Subdivision Staff Report

| Subdivision Name | Emerald Station Subdivision | File Number | SUB08-00047 |
| Approval | Preliminary Plat | Lead Agency | Boise City |
| Public Hearing Date | February 9, 2009 | Heard by | Boise City Planning and Zoning Commission |

11 Preliminary Plat
for
EmeraldStation
17.10 Acres Situated in a North 1/2 of the Northeast 1/4 of the Southeast 1/4 of Section 7,
Township 3 North, Range 2 East, Boise Meridian,
City of Boise, Ada County, Idaho
2008

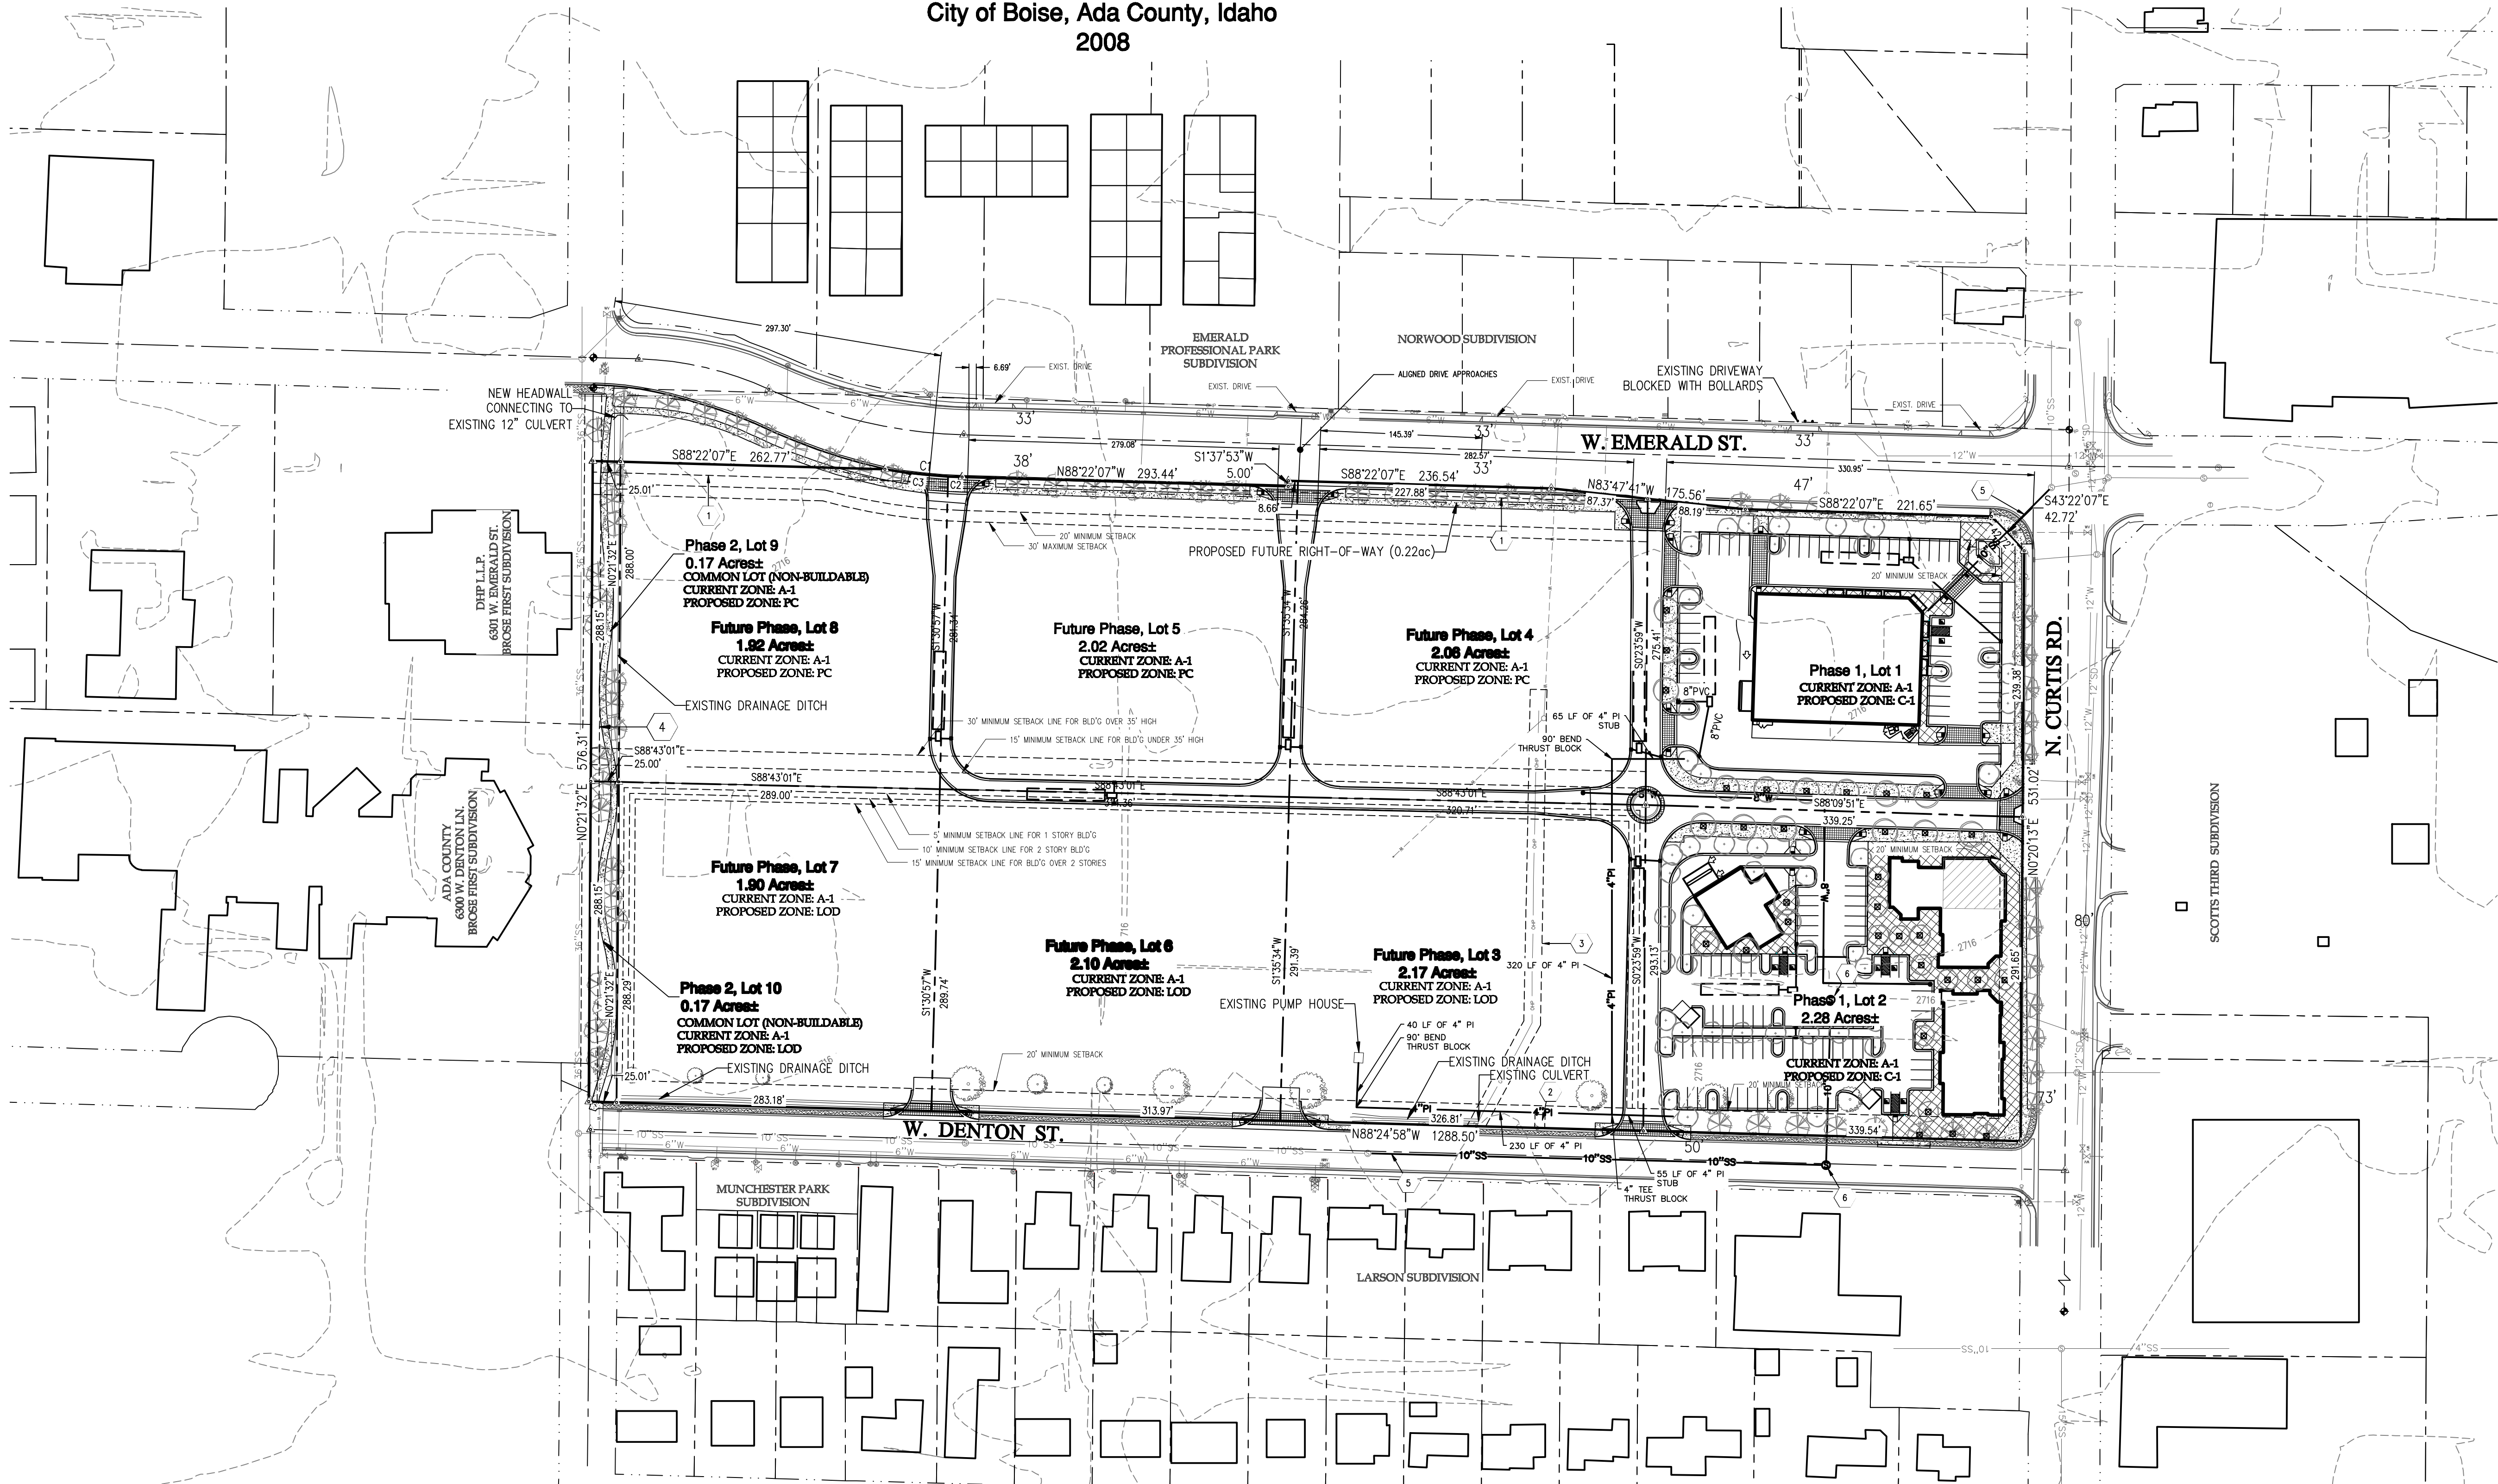
No fire hydrants have been noted on plat. In the absence of information on existing hydrants it appears that one or more new hydrants may/will be needed. However, we reserve the right to modify requirements as more information comes to light. Variables affecting hydrant numbers and location include, but are not limited to, area, construction type, existing hydrants, accuracy of information provided in the application, strategic location for fire fighting forces, and required fire flow. New hydrants must be "non-private" installations.

- The PM peak hour turning movement counts were down after the West Junior High School was closed. Therefore, the trip generation numbers in the PM peak hour cannot be reduced by the estimated school traffic as done in Table 5 of the submitted traffic impact study.

- The submitted traffic impact study states that dual eastbound left turn lanes are needed at build out to serve the site. However, this improvement is not listed in the District's Capital Improvement Plan or Five Year Work Plan. Due to the right-of-way constraints at the intersection and the substantial cost associated with the purchase (purchasing a minimum of two existing businesses) of right-of-way to construct the intersection improvement the District is not requiring the construct of the eastbound dual left turn lane with this application.

Staff Comment/Recommendation: The applicant's proposal meet's District Policy. The applicant will be required to provide the District with a sidewalk easement for any portion of the sidewalk located outside of the right-of-way.

Staff Comment/Recommendation: The applicant's proposal meet's District Policy. The applicant will be required to construct the detached sidewalk a minimum of 41-feet from the centerline of Emerald Street abutting the site. Additionally, the applicant will be required to provide the District with a sidewalk easement for any segment of the sidewalk located outside of the right-of-way.

Staff Comment/Recommendation: Denton Street is already fully improved with curb, gutter, and sidewalk abutting the site, therefore no additional right-of-way or frontage improvements are required with this application. However, Denton Street extends beyond 150-feet and does not have a turnaround at the terminus as required by District policy. Therefore, the applicant will be required to construct a turnaround at the terminus of Denton Street Abutting the site. The applicant could construct either an offset turnaround at the terminus of the roadway, or provide a T-type public turnaround easement encompassing a driveway if a driveway were to be located a minimum of 150-feet from the current terminus of Denton Street.

The applicant's proposal to construct one right-in/right-out driveway on Curtis Road does not meet District Access Management or Successive Driveway Policy, however staff recommends a modification of policy to allow the right-in/right-out driveway to be located, as proposed. Staff recommends the modification of policy for the driveway to reduce the impacts to the Curtis/Denton intersection. The right-in/right-out driveway should intersect Curtis Road approximately 270-feet south of the north property line, as proposed. The applicant will be required to coordinate the design of the pork chop median and a signage program with District Traffic Services and Development Review staff.

1. Construct minimum 5-foot detached concrete sidewalk along Curtis Road abutting the site, as proposed. Provide a sidewalk easement for any portion of sidewalk located outside of the right-of-way.

3. Construct minimum 5-foot detached concrete sidewalk no closer than 41-feet from the centerline of Emerald Street abutting the site, as proposed. Provide a sidewalk easement for any portion of sidewalk located outside of the right-of-way.

4. Construct one cul-de-sac turnaround or with a minimum outside radius of 45-feet at the terminus of Denton Street abutting the site. OR construct an alternative turnaround such as an offset cul-de-sac at the terminus of the roadway, or provide a T-type public turnaround easement encompassing a driveway if a driveway were to be located a minimum of 150-feet from the current terminus of Denton Street.
